GENERAL AVIATION ALLIANCE (GAA) RESPONSE TO THE RAF BRIZE NORTON ACP CONSULTATION

This is the General Aviation Alliance (GAA) response to the RAF Brize Norton (BZN) Airspace Change Proposal Consultation dated 15th December 2017 and should be read in addition to any responses from individual GAA member organisations.

Figure 1 – Position of critical VFR choke points

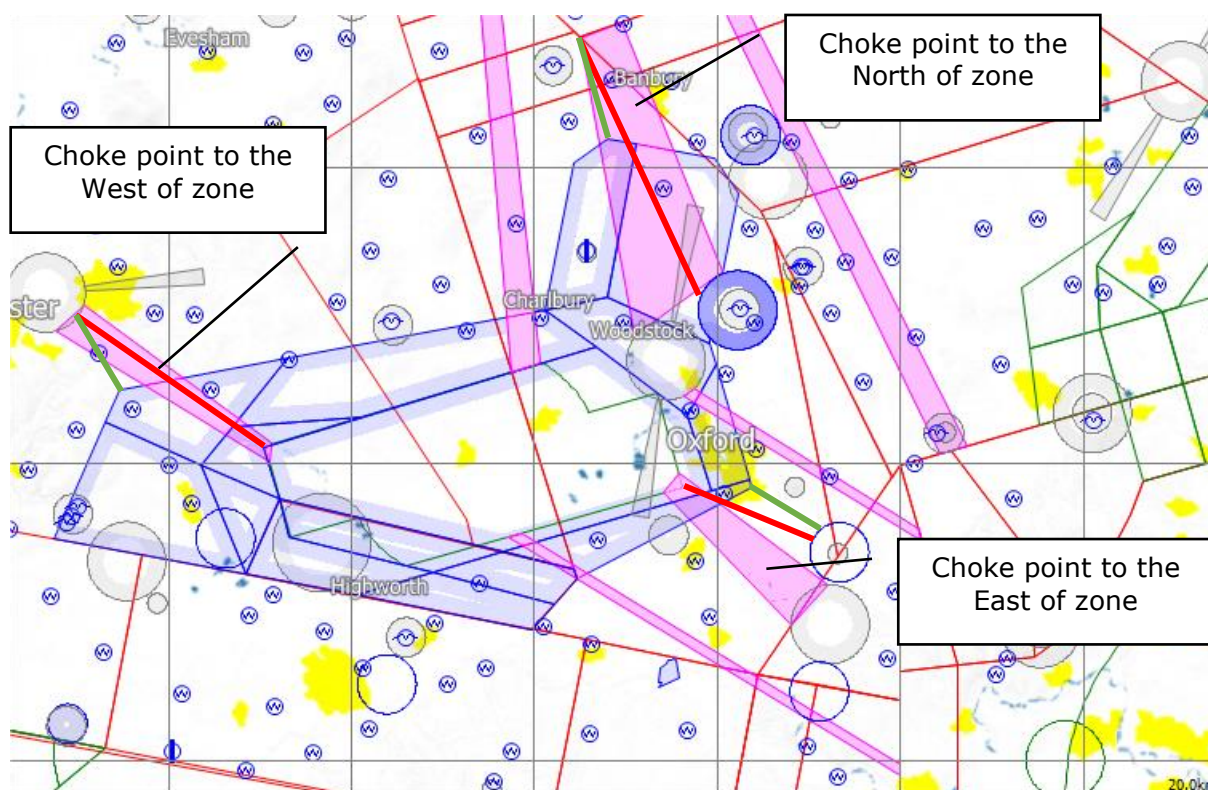
4.1.2 Choke points¹. Following on from the above, the sponsor has failed to properly evaluate the safety risk to GA at choke points where traffic density is likely to be increased as a result of the ACP. Extant GASCo advice to fly with no less than 2nm lateral and 200ft vertical separation from controlled airspace creates a further reduction in available airspace at such hot spots, which also needs to be taken into consideration. The very real risks associated with choke points were highlighted in AAIB Report 5/2010 which concerned a fatal mid-air collision between RAF Brize Norton and RAF Benson. Section 1.11.6 of the Report showed that the level of GA activity in that area can be around 75 aircraft per hour and between 15-25 aircraft at any one time. This is a level which would significantly exceed RAF Brize Norton's stated ATSOCAS handling capability of 8 aircraft simultaneously (5 Traffic Service plus 3 Deconfliction Service) by a single controller. The consultation document, however, makes no mention of enhancing the capacity of RAF Brize Norton's ATC establishment to meet demand from GA traffic requesting crossing clearances through the increased volume of Class D airspace. Without such an uplift, the proposal is likely to result in 'management by exclusion' which is specifically prohibited in Appendix 5 of CAP 725.

4.1.3 Increased collision risk. QinetiQ Report 10/02707 'Class G Airspace Modelling', to which the sponsor makes no reference, states '... the activity that takes place within Class G airspace is sufficiently well understood and predictable in its nature, such that the level of activity at any time can be calculated. More specifically, modelling can quantify the expected level of use and identify activity hotspots'. We have analysed present and proposed airspace widths and heights at known and projected choke points and have estimated the change in collision risk based upon guidance contained in AAIB Report 5/2010 if the majority of GA traffic elects (as is likely) to route around the proposed controlled airspace.

This analysis suggests that the risk of mid-air collision is roughly doubled at the south-eastern edge of the proposed airspace in the Brize Norton-Benson gap (East), and roughly trebled over the proposed Oxford CTR1 (North) and in the area around Kemble (West). Wholesale adoption by VFR traffic of extant GASCo recommendations regarding proximity from controlled airspace would see these risk levels elevated by an order of magnitude. Overall, we believe that the sponsor's decision not to conduct a meaningful analysis of either the RAF Brize Norton ATC capacity or the collision risk at GA choke points has wilfully misled the reader in respect of the level of risk that would be transferred to other airspace users, particularly GA.
